Mod for Debug Board 11683A, R36.

Convert R36 from Pull-down to Pull-up.

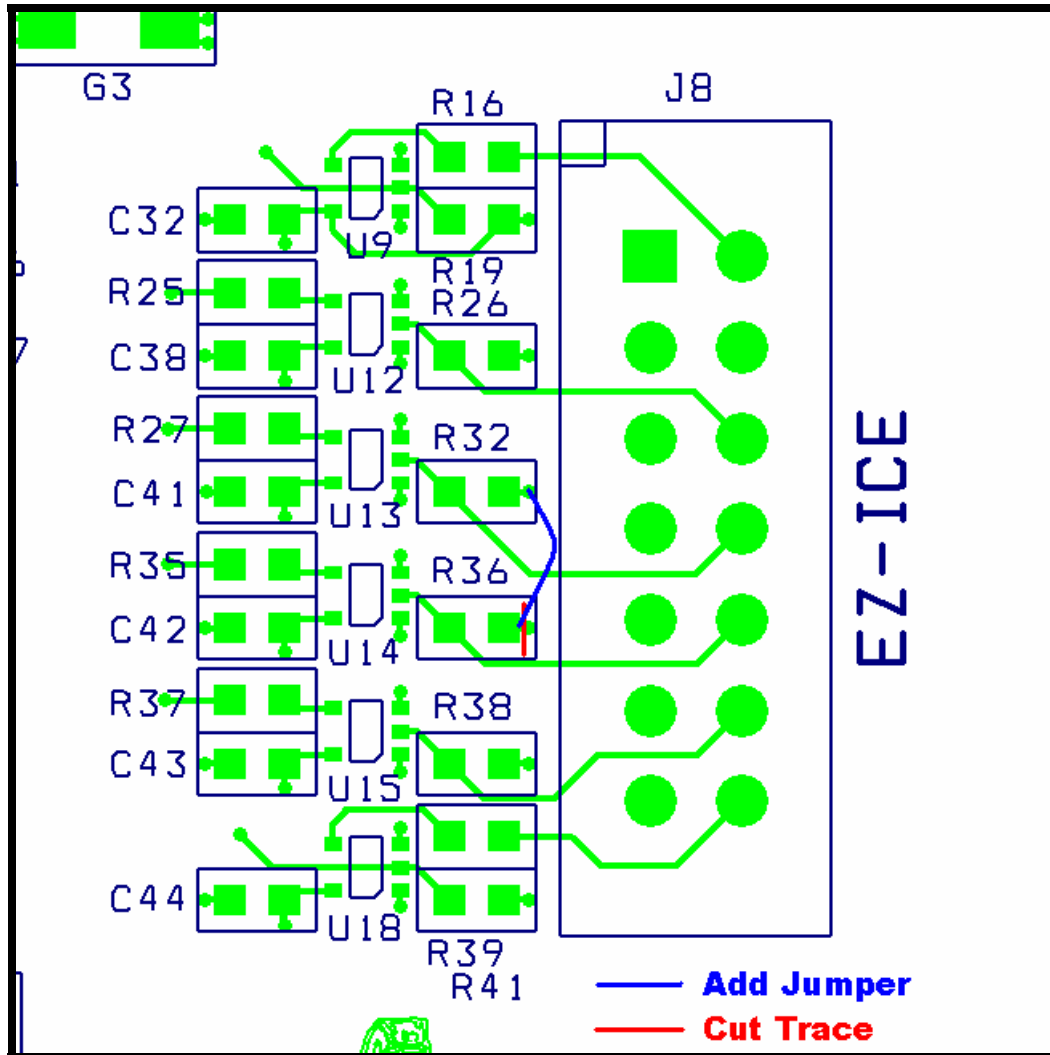
This modification seems to have eliminated “Erasing Sector 0” errors during programming.

This modification will pull BDTRST- high when nothing is connected. This, in turn, will pull the TRST- pin on the ADSP chip of the board-under-test high. This allows JTAG operation. When the test cable is not connected from the debug board to the board-under-test, a resistor pulls the TRST- pin of the ADSP low, preventing the chip from unintentionally entering a test mode.

1. Cut trace from R36 to via that connects to ground (see red mark in drawing for location).
2. Add jumper from same pin of R36 to R32 via. This via connects to 3.3V

Test cables that connect to the Xilinx and EZ-Ice connectors on the Debug Board should also be modified. Any existing jumper from pin 2 to Pin 10 of J8 (EZ-Ice connector) should be removed.
